Design Response Conference 8/25/2009

Building A Massing & Material Modulation

Notes from 8/31/09 DRB Meeting

Master Plan and Design Guidelines
Page DG-24 – Gateway District: Building
Design

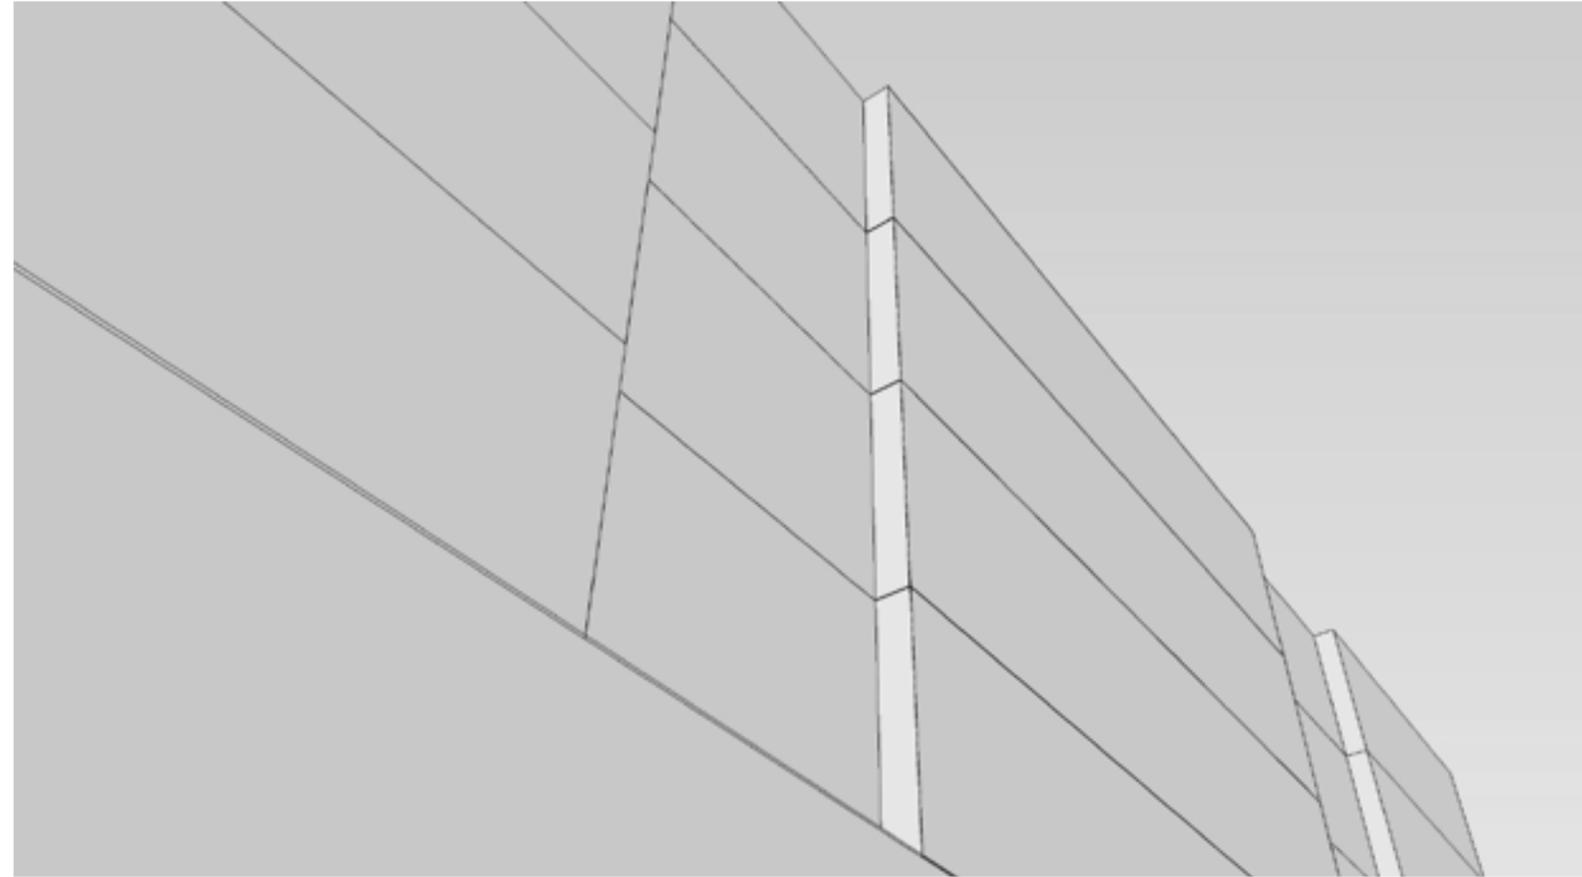
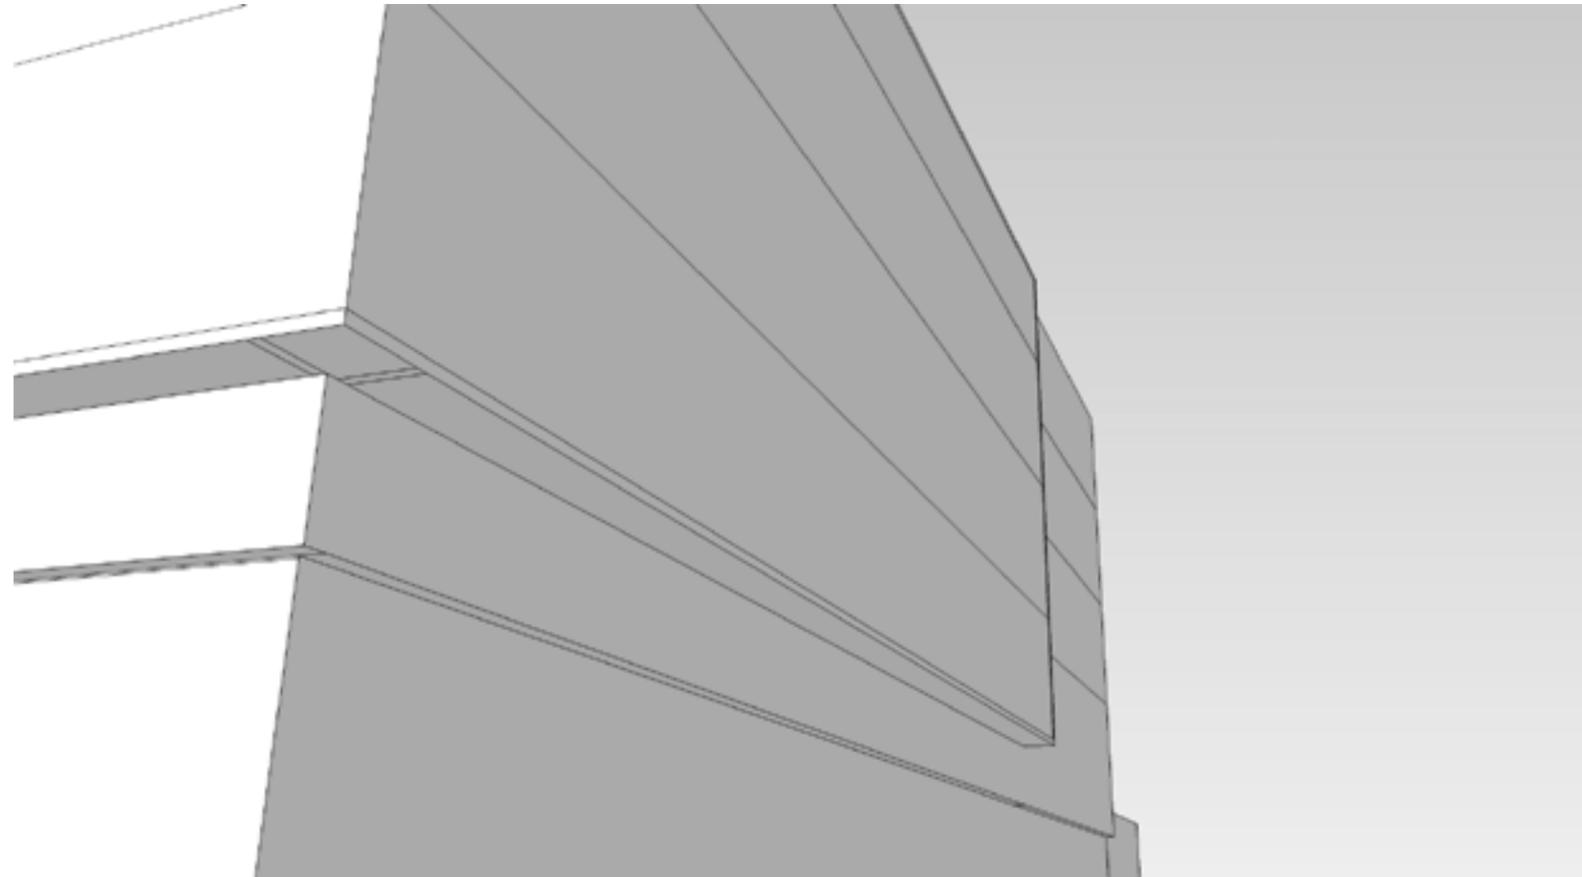
DRB comment: Top floor/roof edge: this will develop with the massing. Look at how the building steps back and that will determine how to address the top of the building.

Response: The required horizontal modulation along Central Way when viewed from the sidewalk creates a varied roof-line silhouette against the sky.

Master Plan and Design Guidelines
Page DG – 20 – All Districts: Bldg. Design

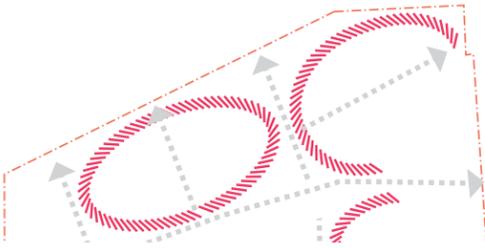
DRB comment: Concerns with Building A Central Way elevation. Does weave concept address pedestrian scale??

Response: 'Weave' concept deals with urban scale reading of the building skins above street level, i.e. not in the pedestrian zone. Illustration shows how the 2-story articulation on building B helps reduce the apparent scale of the building when seen from a distance.
